Access Compliance Report Public Rights-of-Way (Curb Ramps)

Main Street: BLUE_SPRUCE_DR Cross Street: SCOTCH_PINE_DR Location: NW

ADA ID: RPAT211101142940 Ramp Type: Type 4 - Parallel Initial Pass/Fail: Fail Overall Compliance: No Severity Score: 32

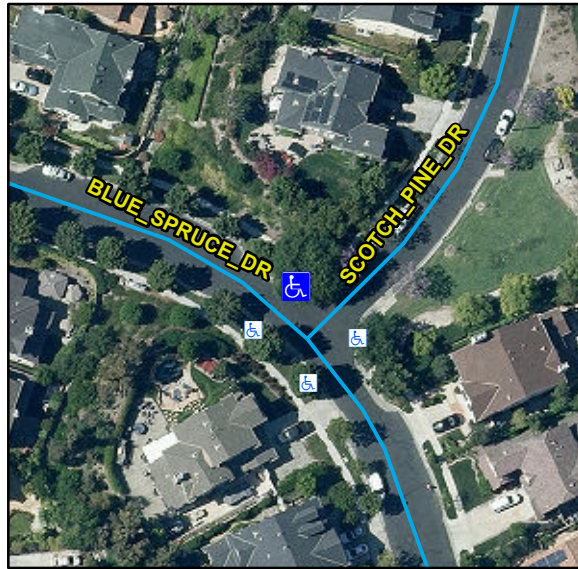
R204.3, R304.3.2, R304.5.3, STD 1115

Compliance	Description	Data	Compliance	Description	Data
N/A	Ramp Length LT (in)	100	N/A	Ramp Length RT (in)	93
Yes	Ramp Width LT (in)	54	Yes	Ramp Width RT (in)	54
Yes	Ramp Run Slope LT (%)	1.1	No	Ramp Run Slope RT (%)	14.8
Yes	Ramp Cross Slope LT (%)	1.9	No	Ramp Cross Slope RT (%)	2.7
N/A	Landing Present	N/A	N/A	DWS Provided	N/A
N/A	Landing Length (in)	N/A	N/A	DWS Contrast	N/A
N/A	Landing Width (in)	N/A	N/A	DWS Length (in)	N/A
N/A	Landing Run Slope (%)	N/A	N/A	DWS Full Width	N/A
N/A	Landing Cross Slope (%)	N/A		DWS Offset Type	N/A
N/A	Landing Movement Obstructed?	N/A	N/A	DWS Offset Left (in)	N/A
	Landing Movement Type	N/A	N/A	DWS Offset Right (in)	N/A
N/A	Landing Shared	N/A			
N/A	Clear Space	Yes			
N/A	Clear Space To Crosswalk (in)	N/A			
N/A	Marked Crosswalk 1	No	N/A	Marked Crosswalk 2	No
	Crossing 1 Direction	SW		Crossing 2 Direction	SE
N/A	Marked Crosswalk 1 Width (in)	N/A		Marked Crosswalk 2 Width (in)	N/A

Remove & Replace Curb Ramp With Two New Directional Ramps or Equivalent.
